Hazelhatch Road, Celbridge, Co. Kildare Flood Risk Assessment

Technical Report
August 2022
2021s1175

C Response to Kildare County Council Comments

Figure 4-5: Baseline Model Results

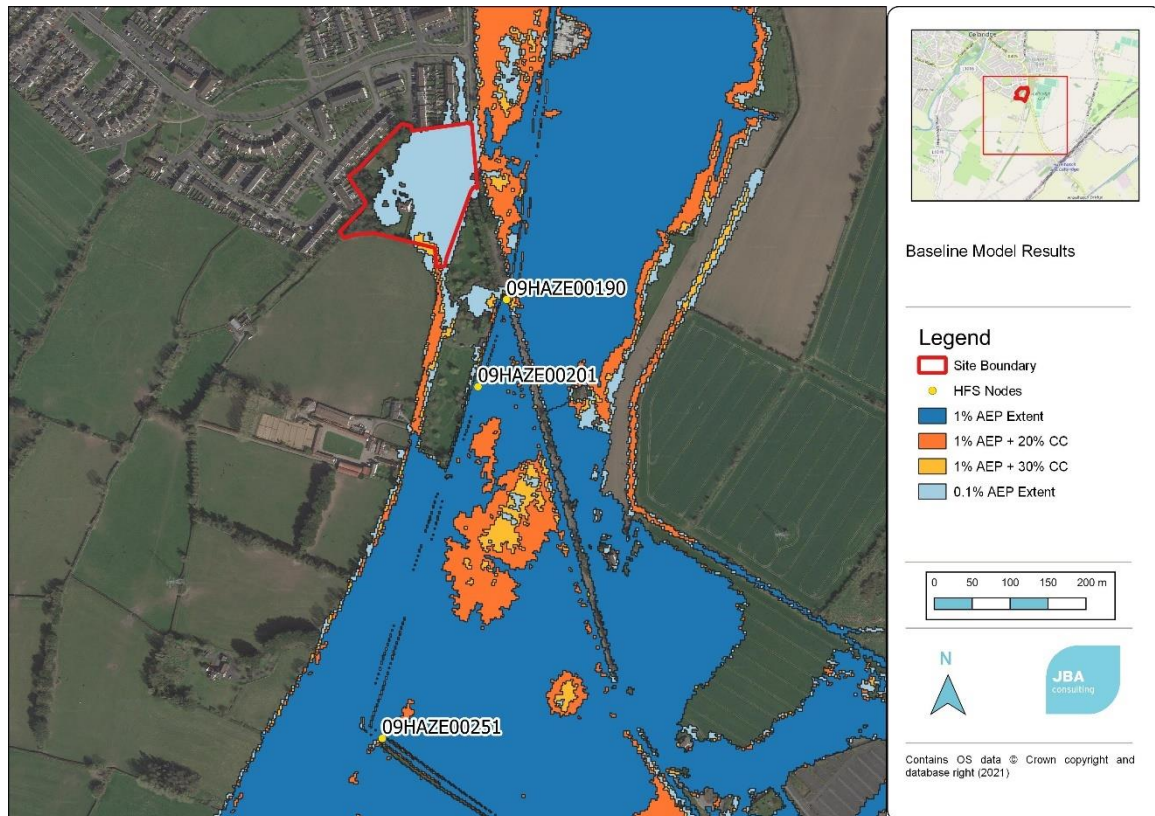
It is a requirement of The Guidelines that a flood zone map is provided to show the 1% and 0.1% AEP outlines. Figure 4-5 in the JBA report indicates that the site lies within the 0.1% AEP flood extent but not the 1% AEP. This would be designated as Flood Zone B. Considering the proposed residential use the FRA has correctly determined that the Development Management Justification Test is required in accordance with Table 3.2 of the Guidelines.

Figure 4-8: 0.1% AEP Post-Development Impacts

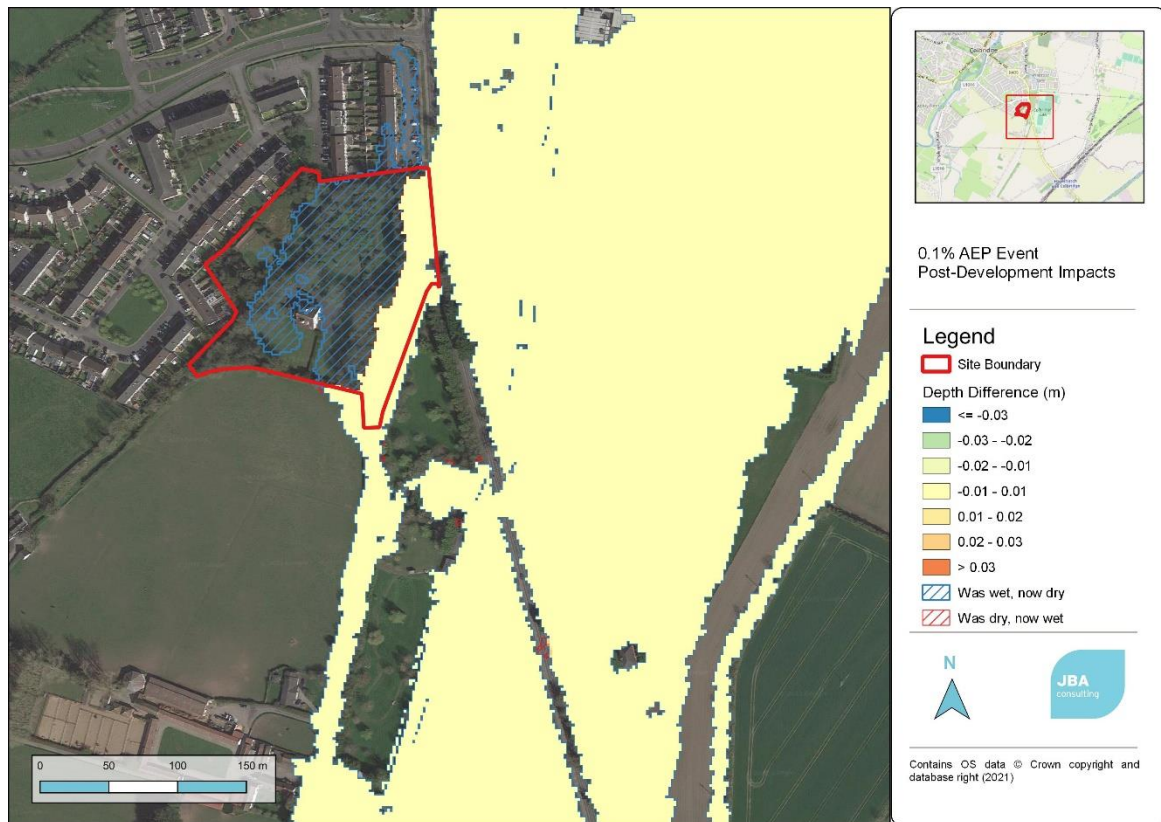
Figure 4.8 indicates there is an overall reduction in flood extent in the 0.1% AEP event because of the protection now afforded to the adjacent development, "The Close". This would be considered a major benefit of the proposed development. The Guidelines only require the impact assessment of the 1% + Climate change event so by using the 0.1% event this would be considered a conservative approach.

Summary – The mitigation measures provided in relation to fluvial and surface water flooding are to a high standard of protection and would be over and above that required in The Guidelines. RPS are satisfied that there is no net increase in fluvial flood risk to the area shown in Figure 4.8, and the reduction of risk to The Close is an added benefit.

RPS would agree this statement has been met given Figure 4.8 indicating no increase in risk and a reduction in risk "The Close" development.
